WATER LICENCE INSPECTION FORM

Licensee	Licensee Representative			
BAFFINLAND IRON MINES CORPORATION	Connor Devereaux			
Licence No. / Expiry	Representative's Title			
2AM-MRY1325	Environmental Superintendent			
Land / Other Authorizations	Land / Other Authorizations			
8BC-MRY1416, 2BE-MRY1421	N2014X0012, N2014Q0016, N2014C0013			
Date of Inspection	Inspector			
May 22-23, 2019	Jonathan Mesher			
Activities Inspected				
☐ Camp ☐ Drilling ☐ Mining ☐ Roads/Hauling ☐ Other:	☐ Construction ☐ Reclamation ☐ Fuel Storage ☐ Other:

Description: Damaged Hazardous Waste containers.

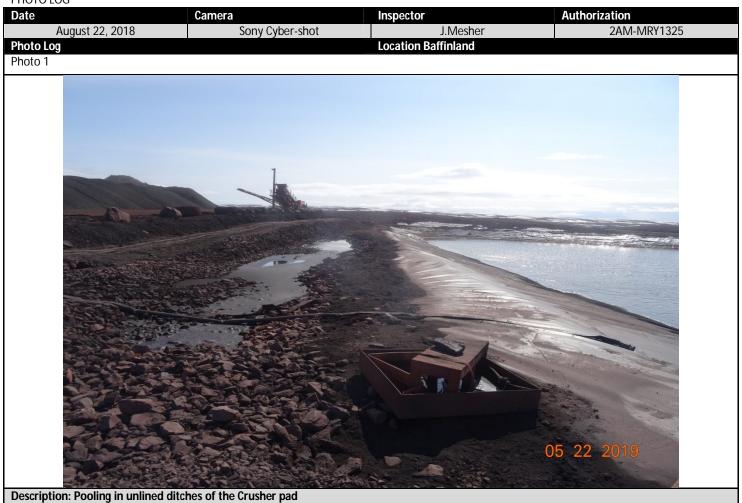
- a. The inspector noted that Hazardous waste berm #7 had limited capacity and the berm walls were inconsistent, the inspector is requesting that the licensee provide the for construction and As-built drawings for all Hazardous waste berms.
- b. The inspector noted damaged containers within the Hazardous Waste Berm, Section 4.4.2of the Hazardous Material and Hazardous waste Management Plan states that; "Regular inspections are performed and recorded. Containers are placed so that each container can be inspected for signs of leaks or deterioration. Leaking or deteriorated containers will be removed and their content transferred to a sound container." The Licensee is to remove all damaged containers and transfer the hazardous material to sound containers. (see Photos #6)

- c. The inspector noted damaged containers within the Hazardous Waste Berm, Section 4.4.2of the Hazardous Material and Hazardous waste Management Plan states that; "Regular inspections are performed and recorded. Containers are placed so that each container can be inspected for signs of leaks or deterioration. Leaking or deteriorated containers will be removed and their content transferred to a sound container.". The Licensee is to remove all damaged containers and transfer the hazardous material to sound containers. (see Photo 7)

- **3.** The licensee is to remove all Hazardous material from any damaged containers and place it in sound containers.
- **4.** The licensee is to repair/ Key-in the liners at MP-05 and MP-06 to ensure all runoff is proper captured.

Photo 8

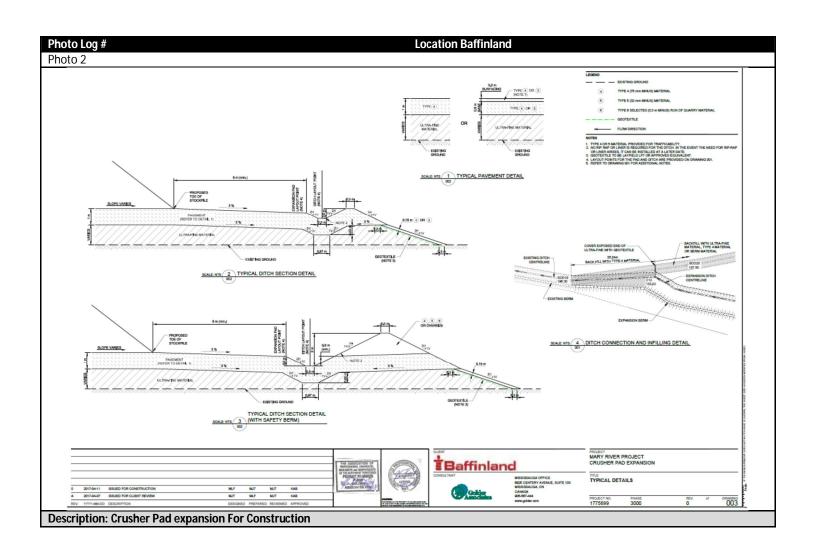
- a. During the inspection there was machinery operating in the hazardous waste berm and significant staining from spills in the facility, the machinery was freely driving in and out of this facility potentially spreading the spilled hazardous material and contaminating the surrounding area. The inspector is requesting that the licensee remove the contaminated soil and appropriately dispose of it. (See Photo 8)

- b. The inspector noted that the licensee has recently placed new crushed rock in the facility over a portion of the spilled area and had absorbent material scattered over the affected area.(See Photo 8)
